NORTHERN BEACHES LOCAL PLANNING PANEL

FRIDAY 3 DECEMBER 2021

ITEM 4.1	MOD2021/0178 - 138 -139 NORTH STEYNE, MANLY - MODIFICATION OF DEVELOPMENT CONSENT DA2018/0723 GRANTED FOR DEMOLITION WORKS AND CONSTRUCTION OF A RESIDENTIAL FLAT BUILDING
AUTHORISING MANAGER	Lashta Haidari
TRIM FILE REF	2021/821470
ATTACHMENTS	1 Assessment Report 2 Site Plan & Elevations

APPLICATION FOR MODIFICATION ASSESSMENT REPORT

Image 1 - Superseded Level 1 plan

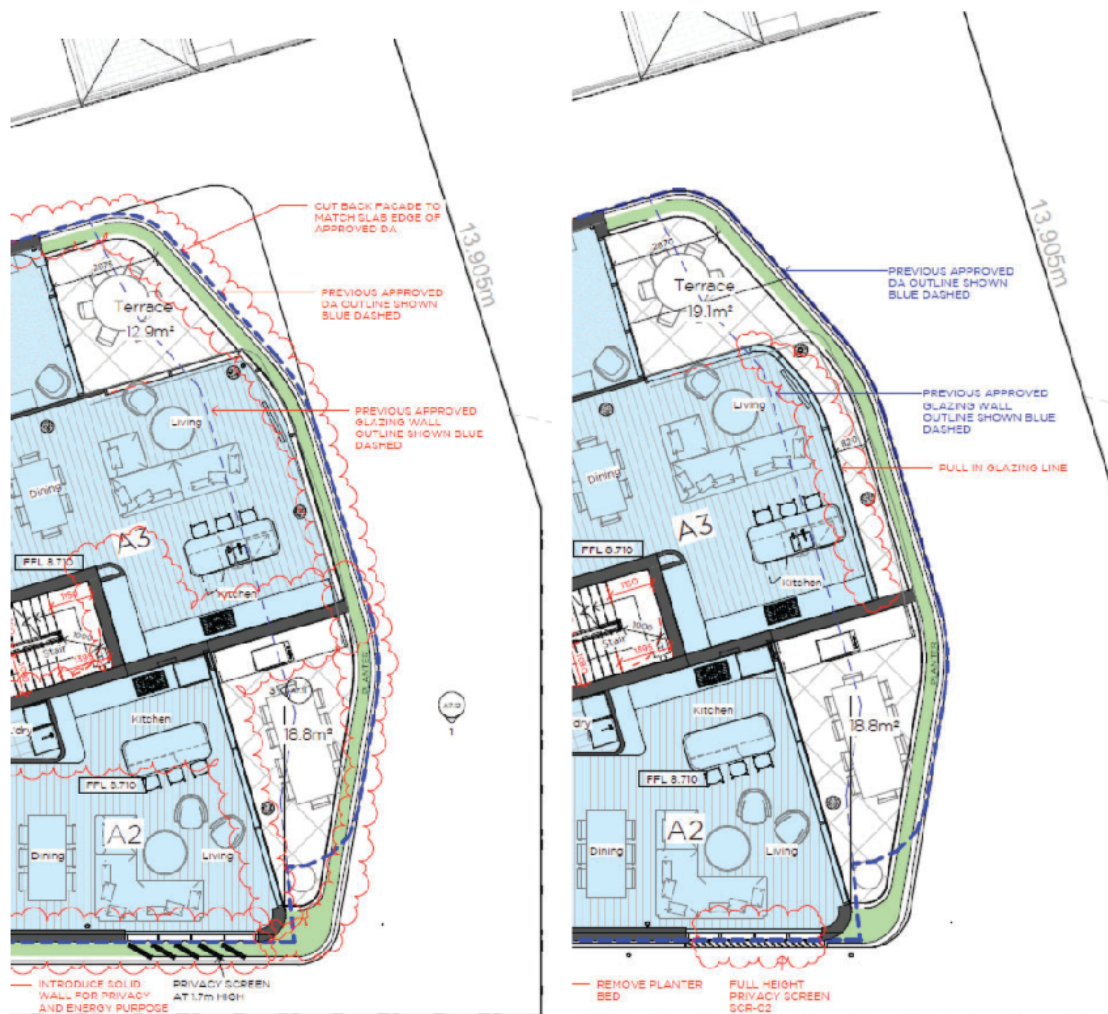
The modified front setbacks at Levels 1 and 2 were one of primary issues contributing to the recommendation of refusal presented to the NBLPP on 20 October 2021. Whilst the footprint of the original development was to be maintained, the plans previously presented to the panel proposed to reduce the setback of the central portion of the front façade, resulting in the removal of the central part of the front balconies and two large expanses of glazing only 5.3m from the front boundary. In

The previously proposed front setbacks are shown in Image 1, with the revised setbacks in the amended plans shown in Image 2. Both images also demonstrate the approved façade alignment, with the balcony edge indicated by the thicker blue dashed line and the alignment of the external enclosing walls indicated by the finer blue dashed line.

In response to these concerns, the applicant has increased the setback of the external walls of Levels 1 and 2, to maintain the full width balcony along the front façade. Whilst the central portion of the enclosing walls remain forward of the approved alignment, this is reasonably off set by the proposed increases to the setbacks of the walls at the front corners, such that the presentation to North Steyne and the bulk and scale of the development remains substantially the same as that which was originally approved.
